**UMMC PROJECT NO. 409-007
FIRE PROTECTION CENTRAL CORE
UNIVERSITY OF MISSISSIPPI MEDICAL CENTER
JACKSON, MISSISSIPPI**

Addendum No. 1

August 5, 2026

This addendum forms a part of the contract documents and modifies the original plans and specifications dated June 12, 2026.

sheet no.
FP201-D

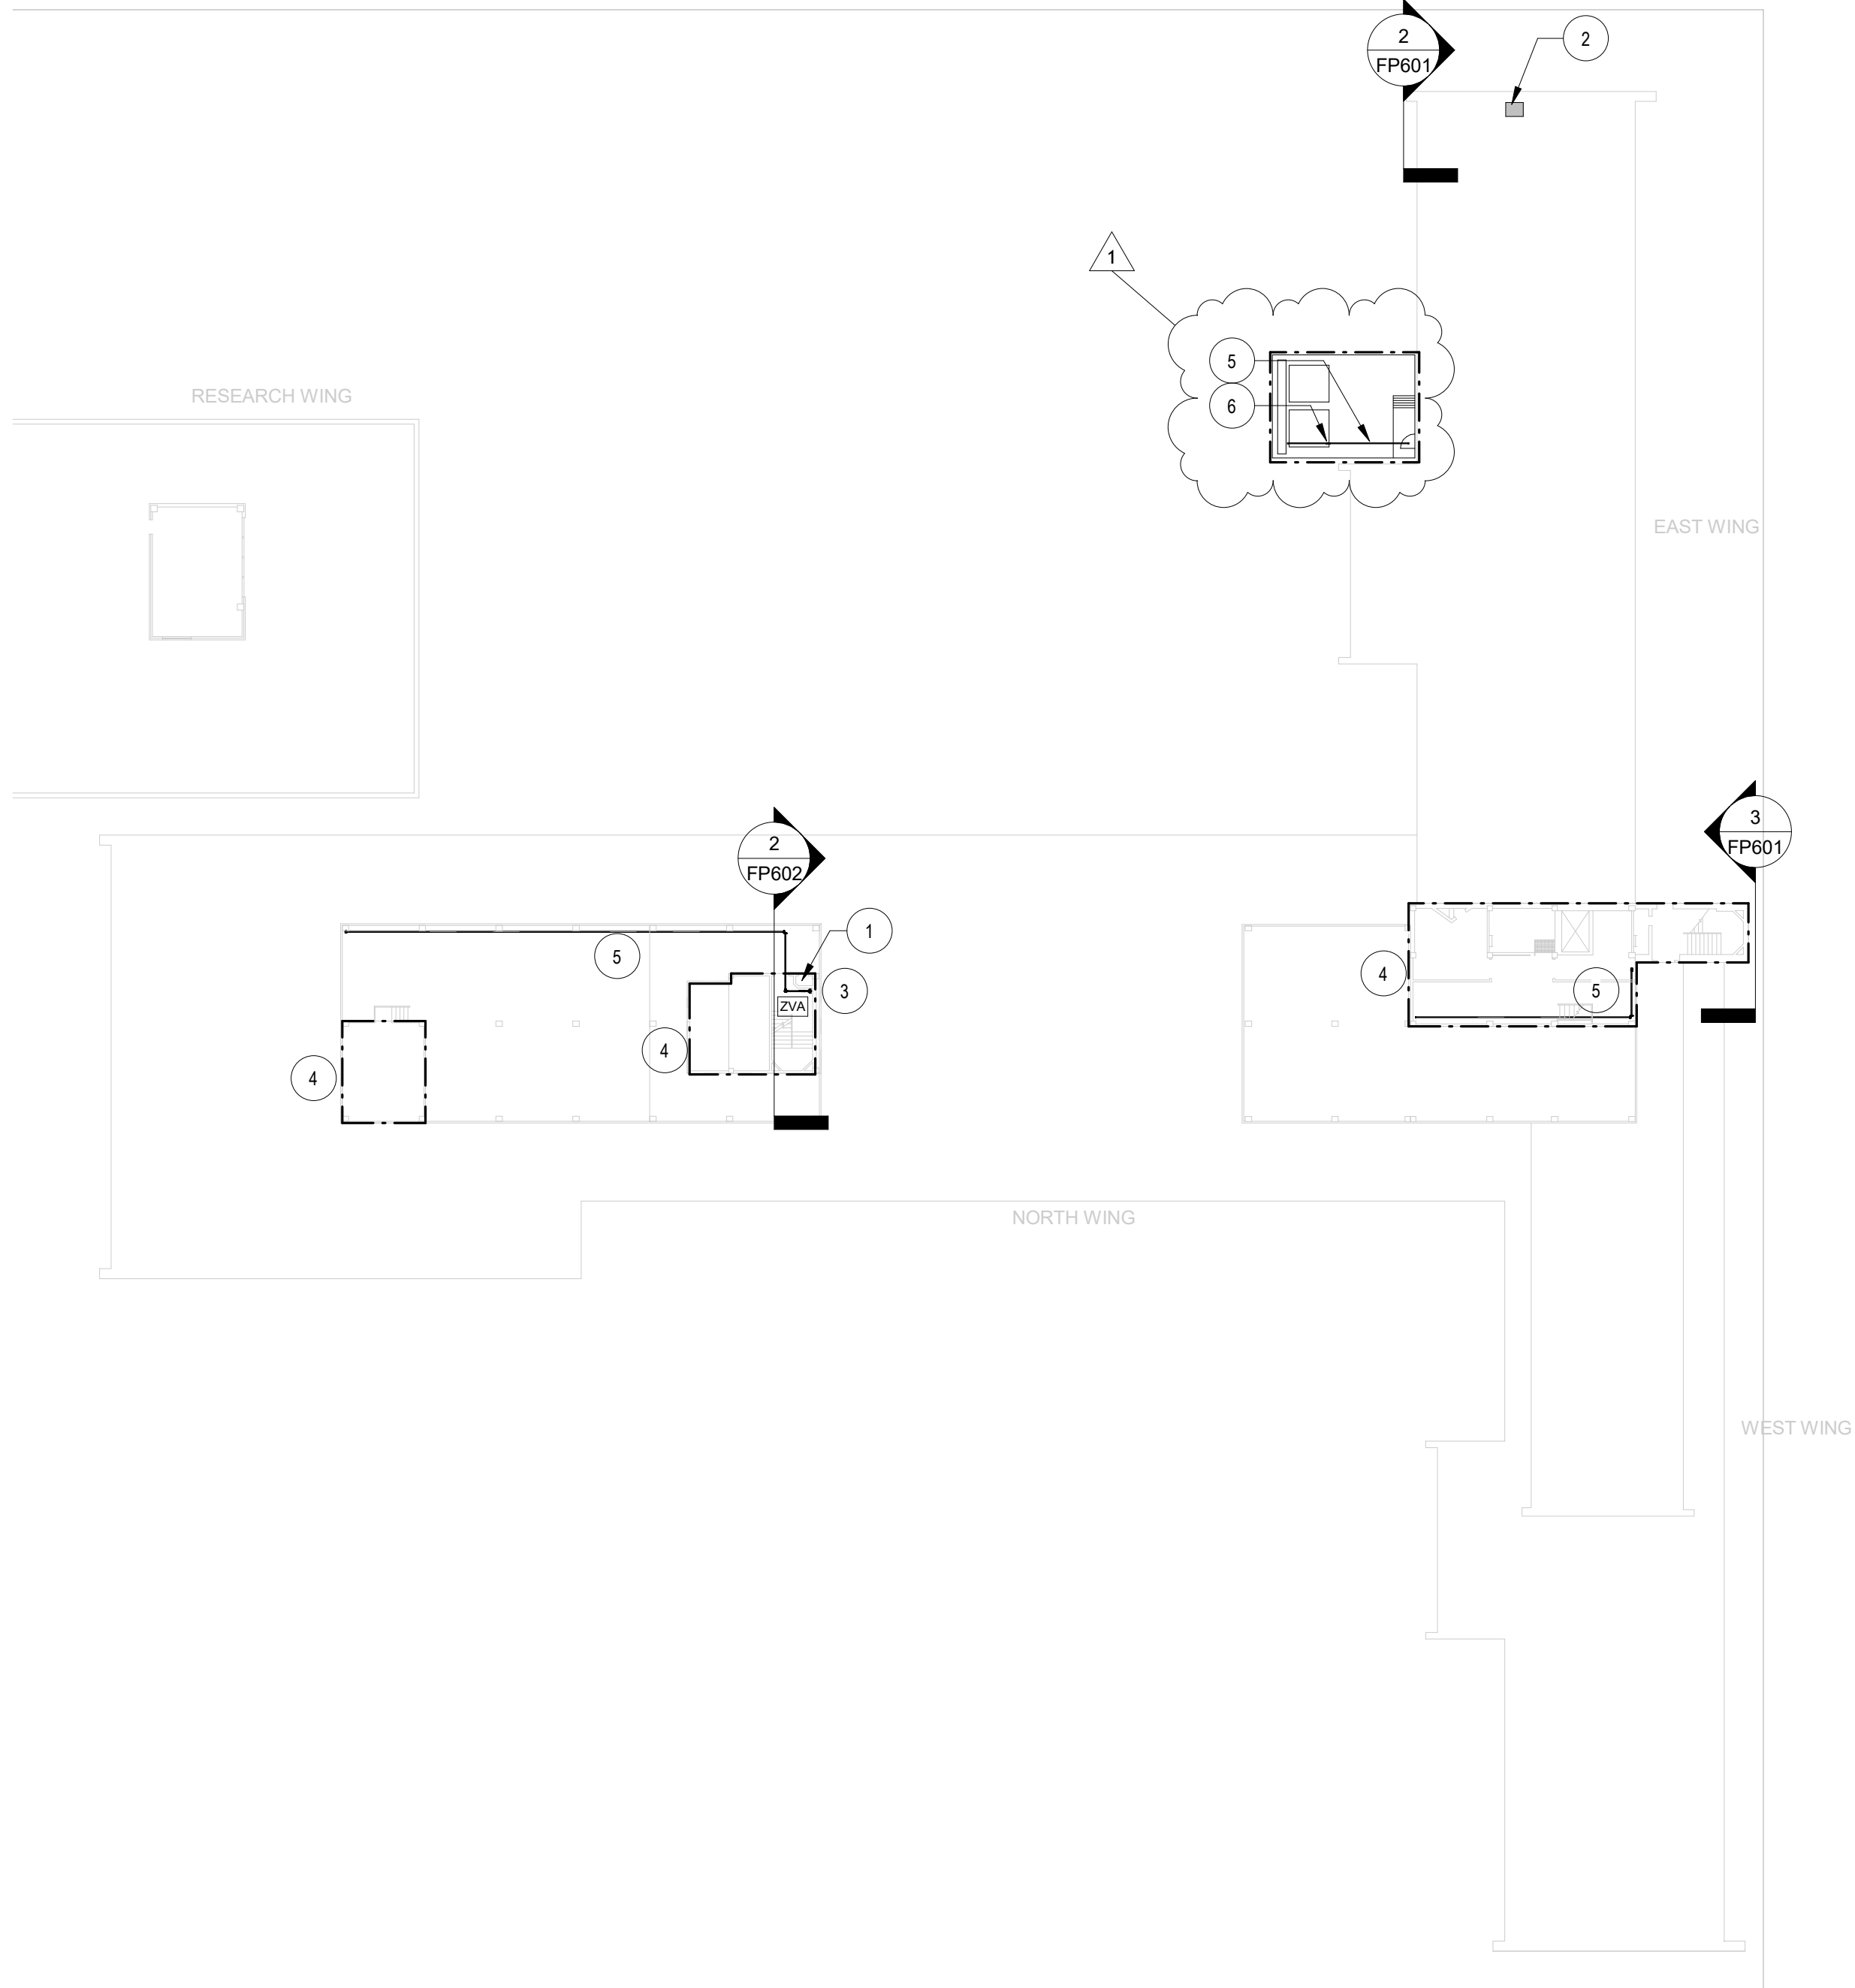
- A. Sheet FP201, Sub-Basement Overall New Work:
 - 1. New sprinkler zone scope boundary added.
- B. Sheet FP201-D, Sub-Basement Overall Demolition
 - 1. Pressure relief drainpipe demolished back to exterior wall.

sheet no.
FP211

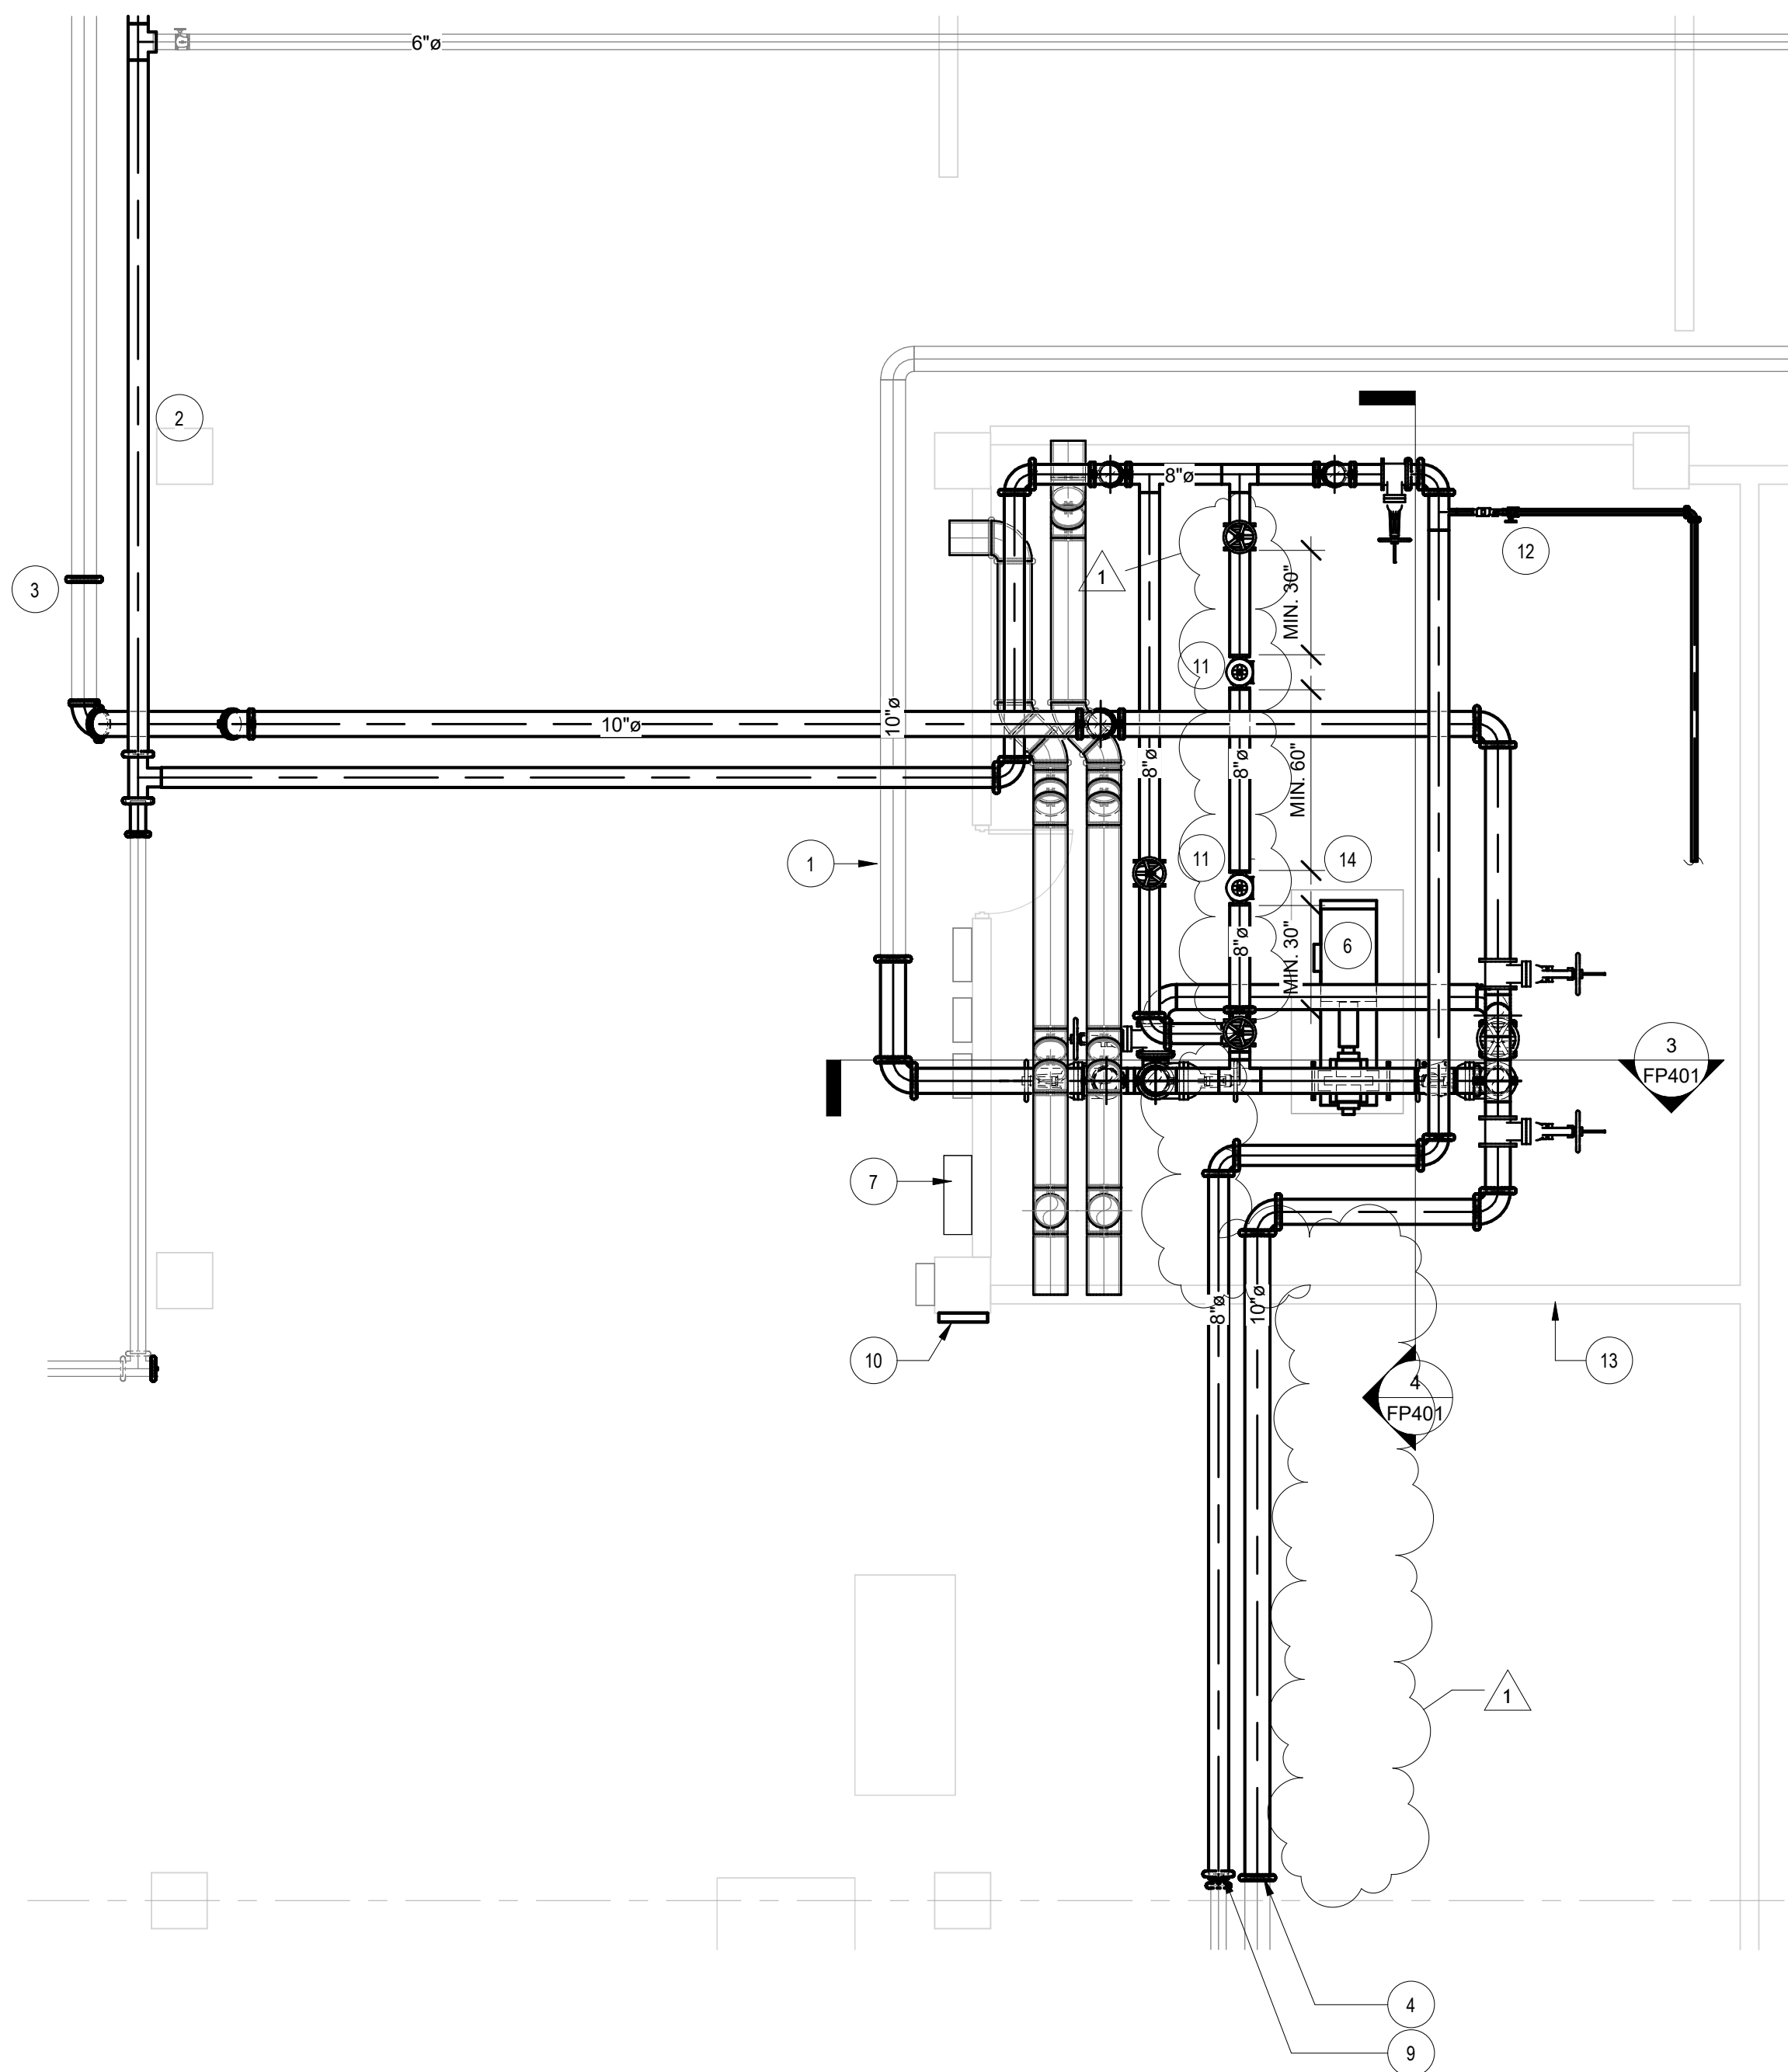
- C. Sheet FP202, Basement Overall New Work
 - 1. Stair N-01 new 6" standpipe connected into existing basement loop feed main.
- D. Sheet FP211, Penthouse Overall New Work

- 1. New sprinkler zone scope boundary added.
- E. Sheet FP401, Fire Pump Enlargement Plans New Work
 - 1. New pressure relief piping removed.
 - 2. PRVs and connected piping increased in size from 6" to 8".
